## General Information

*GI-1 Comparison between the topographical features in License Application (LA) Figures 1-3 and 1-4 gives the impression that the 640-acre plot would extend beyond the county sections represented in Figure 1-4. Consistent with NUREG-1520, Section 1.1.4.3(2), trace out the 640-acre property on LA Figure 1-4, similar to LA Figure 1-3, to clarify how county Sections 26, 27, 34 and 35 overlap with the 640-acre property.*

**License Documentation Impact:** Figure 1-3 in the License Application Revision A, Chapter 1, Section 1.1.1 will be replaced with the revised Figure 1-3 below. Also, paragraph three of the Section 1.1.1 will be revised to read as follows:

GI-10

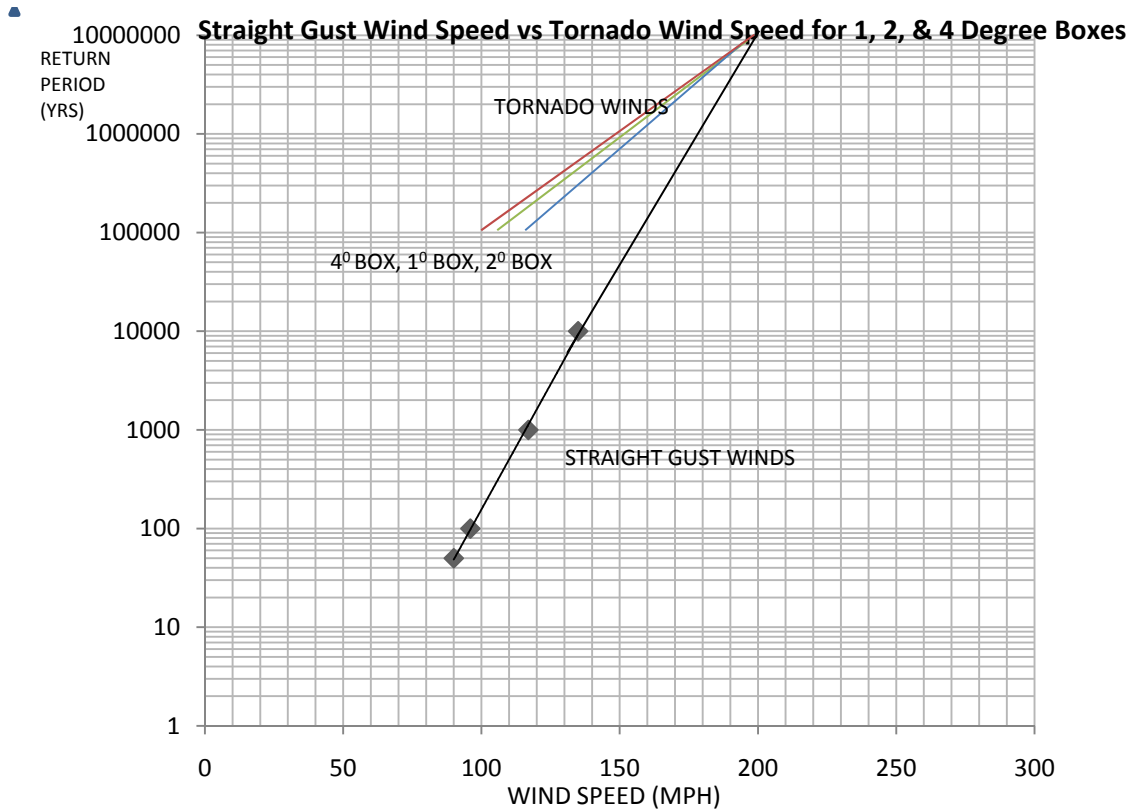
- C. *The basis quoted in ER Figure 3-27 for IIFP being outside the 100-year flood plain is based on data provided by the Economic Development Corporation (EDC) of Lea County, NM. In response to this RAI, provide a basis for the credibility of the information. Indicate if the EDC is qualified to develop these reports, or specify that the EDC compiled the information from nationally recognized sources. In addition, in the LA, ISA Summary, and ER, provide a basis for the statement that the IIFP is outside the 500-year flood plain.*

**License Documentation Impact:** The source reference for the floodplain information shown in Section 3.4.1.1, Figure 3-27 of Revision A of the IIFP Environmental Report will be changed from the EDC to include provider to EDC, FEMA and USGS.

Site grade is significantly above areas which have been mapped and are in the 100-year floodplain in and around Hobbs, New Mexico according to information provided in the FEMA Mapping Information Platform. These mapped areas and topographical data are displayed in Section 3.4.1.1, Figure 3-27, "Watercourses, Floodplains, and Playas Map" for location of FEMA Zone A (areas inundated during 100-year flood event). This map was provided to the Economic Development Council of Lea County by Gordon Environmental Inc. who references FEMA as the
